**PLANNING APPROVAL,  
PLANNED UNIT DEVELOPMENT  
& SUBDIVISION STAFF REPORT**

**SUBDIVISION NAME** Willard Subdivision, First Addition, Resubdivision of Lots 3 & 4, and Resubdivision of Lots "A" & "B" of the Resubdivision of Lots 1 & 2

**LOCATION** 2760 Macmae Drive  
(East and South sides of Macmae Drive at its South terminus)

**CONTEMPLATED USE** Planning Approval to allow warehousing in excess of 40,000 square feet in a B-3, Community Business District, Subdivision approval to combine two lots of record into one lot and adjust existing buffers for all included lots and one drainage/utility easement for one lot, and Planned Unit Development approval to allow three warehouse buildings and one office building on a single building site.

# SITE PLAN

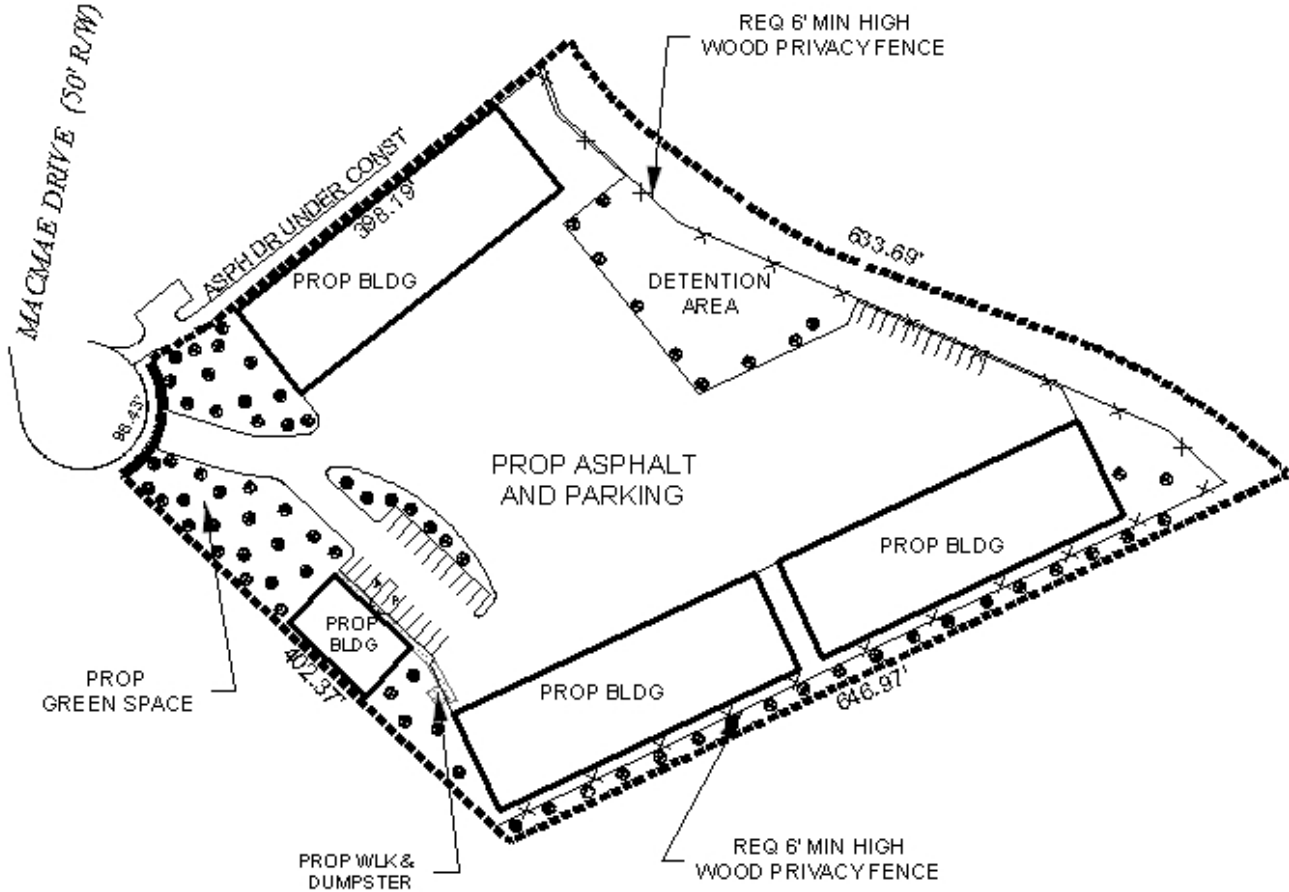
It appears that additional landscaped area could be provided along the Eastern portion of the site, which is currently depicted as being paved, and that includes some employee parking. A paved area North of the proposed detention area, between the building and Bolton's Branch, appears unnecessary, and could be converted to landscape area with trees (trees located outside of the sewer easement). South of the detention area, it appears that the warehouse employee parking area could be shifted to the West to allow additional landscaping and trees (trees located outside of the sewer easement) to provide some vegetative buffering between the development on the site and the homes located in the Mertz Court subdivision.

As the proposed new development will be adjacent to existing residences, the applicant should ensure that any lighting provided on the site will comply with the Zoning Ordinance requirement that states that lighting "*shall be so arranged that the source of light does not shine directly into adjacent residential properties or into traffic.*" A note should be placed on the PUD site plan reflecting the Zoning Ordinance lighting requirement.

The site plan was revised to depict the location of the storage area for the dumpster, with screening that complies with Section 64-4.D.9. of the Zoning Ordinance.

revision of the site plan to include the following as a note on the site plan, “*Lighting shall be so arranged that the source of light does not shine directly into adjacent residential properties or into traffic, per the requirements of Section 64-4.A.2. of the Zoning Ordinance*”; 3) revision of the site plan and plat to depict a 25-foot wide landscaped vegetative buffer (natural or created) area along the South property line, where the site abuts existing residential development in the Belvedere Park subdivision, in addition to the 6-foot high privacy fence and landscaping depicted on the site plan; 4) revision of the site plan to depict a reduction in the paved area on the Eastern portion of the site, and the provision of additional landscaped area and trees (trees to be located outside of the sewer easement), to create a green buffer between the site and the Mertz Court subdivision – to be coordinated with Urban Forestry; 5) placement of a note on the site plan stating that the Planning Approval and PUD approval are site plan specific, and that any changes to the site plan will require Planning Commission review and approval; 6) placement of a note on the final plat and site plan stating that approval of all applicable federal, state and local agencies is required prior to the issuance of any permits or land disturbance activities; 7) provision of a revised site plan to the Planning Section of Urban Development prior to the recording of the final plat; 8) completion of the Subdivision process; and 9) full compliance with all other municipal codes and ordinances.

# SUBDIVISION PLAT

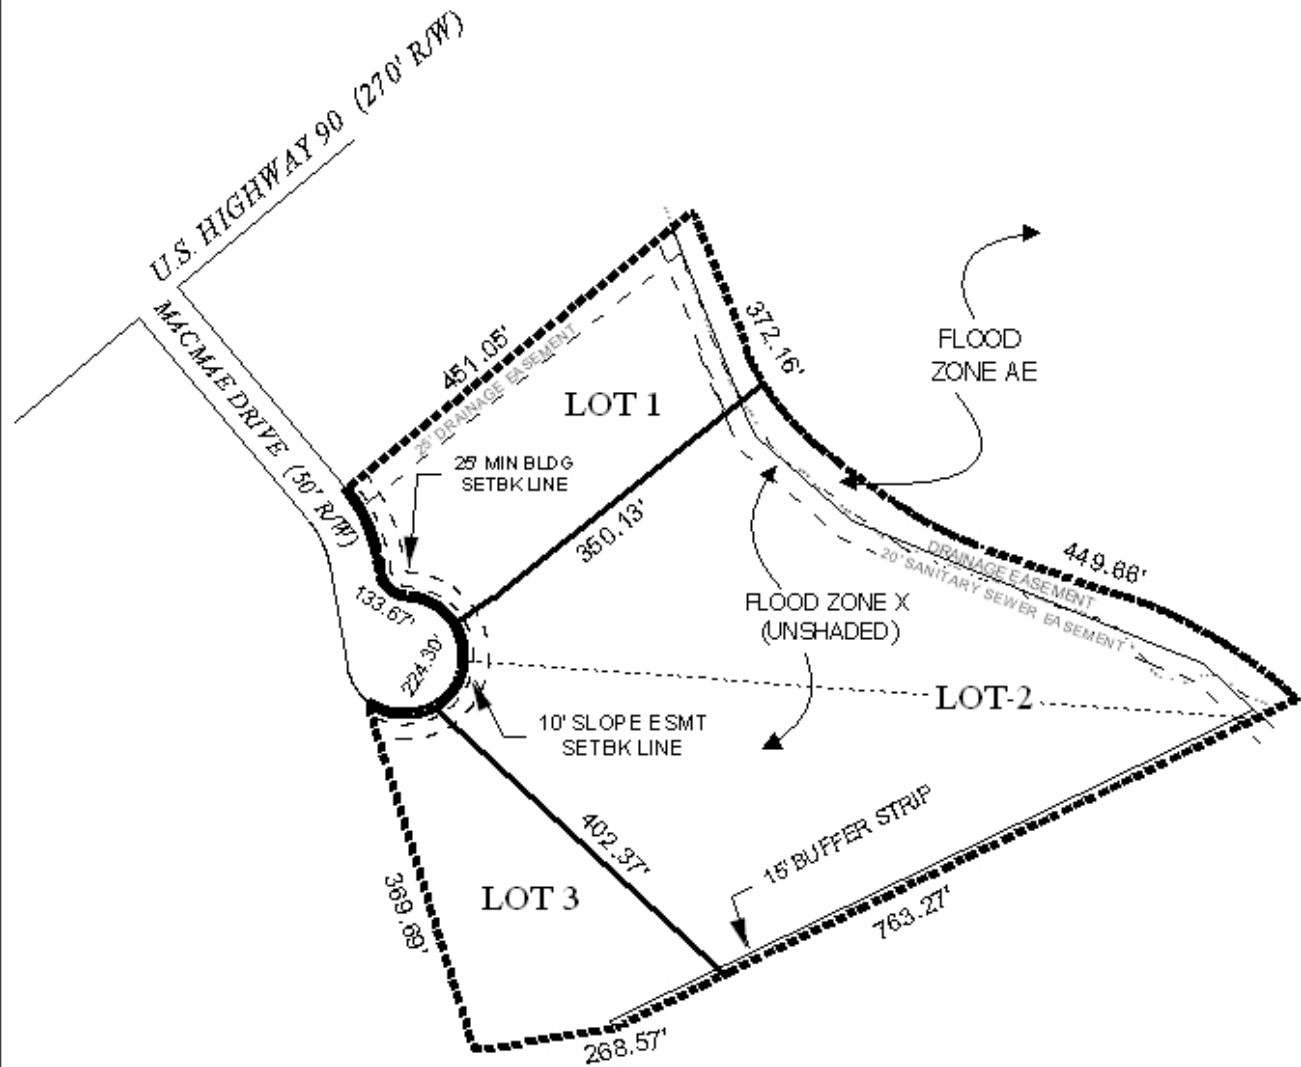
**ENGINEERING COMMENTS** Recommend NO reduction of drainage easements due to the existence of an outfall pipe from Macmae Drive. When the outfall requires maintenance, the full width will be required for probable excavation and vehicle access. The easement along Bolton's Branch is necessary for maintenance vehicles. In addition, the sanitary sewer easement should not be reduced without the approval of the MAWSS.

The purpose of this application, as it relates to Subdivision approval, is to combine the existing lots 2 and 3 into one lot, and to reduce the 75-foot buffer strip depicted on the South and East sides of existing lots 1-4 to 15 feet along the South property line, and to varying widths along the East property line (essentially to conform to the existing drainage easement width of approximately 20 feet). It also appears that the existing 15 foot drainage easement near the Southeastern corner of the existing Lot 2 will be eliminated: all other existing drainage and utility easements will remain.

Engineering has recommended that all existing drainage easements be kept at their current size. Engineering also indicates that the area generally has drainage problems, thus development on the site must fully comply with the stormwater management and flood control requirements.

Properties to the East and South of the site under consideration, in the Mertz Court and Belvedere Park subdivisions, are developed with single-family residential homes. The buffers depicted on the plat and on the site plan meet or exceed those required by the Subdivision Regulations and Section 64-4.D. of the Zoning Ordinance. However, maintaining at least a 25-foot landscaped area (to act as a buffer after construction) and minimum building and development setback, as well as providing the depicted 6-foot high privacy fence along the South property line, which would still accommodate the construction that has been proposed, is recommended. Noise from frequent truck movements is also a concern, and an increased landscaped area may help ameliorate the problem, especially for the residences located South of

**Subdivision:** Based upon the preceding, this application is recommended for Tentative Approval, subject to the following conditions: 1) full compliance with Engineering comments (*Recommend NO reduction of drainage easements due to the existence of an outfall pipe from Macmae Drive. When the outfall requires maintenance, the full width will be required for probable excavation and vehicle access. The easement along Bolton's Branch is necessary for maintenance vehicles. In addition, the sanitary sewer easement should not be reduced without the approval of the MAWSS. Any stormwater that currently flows across the property (from the west) must be accommodated. And the minimum finished floor elevation is required on any lot affected by the AE flood zone. Must comply with all stormwater and flood control ordinances. Any work performed in the right of way will require a right of way permit. The applicant is responsible for verifying if the site contains wetlands. The site can be checked against the National Wetlands Inventory on the COM web site Environmental Viewer. If the site is included on the NWI, it is the applicant's responsibility to confirm or deny the existence of regulatory wetlands.*); 2) depiction of the size of each lot in square feet on the final plat; 3) depiction of a 25-foot wide building and parking setback along the South property lines, where the lots abut existing residential development in the Belvedere Park subdivision, and placement of a note on the plat stating that the this setback area shall be landscaped to provide a buffer, or left in its natural state; 4) placement of a note on the final plat and site plan stating that approval of all applicable federal, state and local agencies is required prior to the issuance of any permits or land disturbance activities; 5) placement of a note on the plat stating that access is denied to Belvedere Circle East; 6) provision of a revised PUD site plan to the Planning Section of Urban Development prior to the signing and recording of the final plat; and 7) full compliance with all other municipal codes and ordinances.
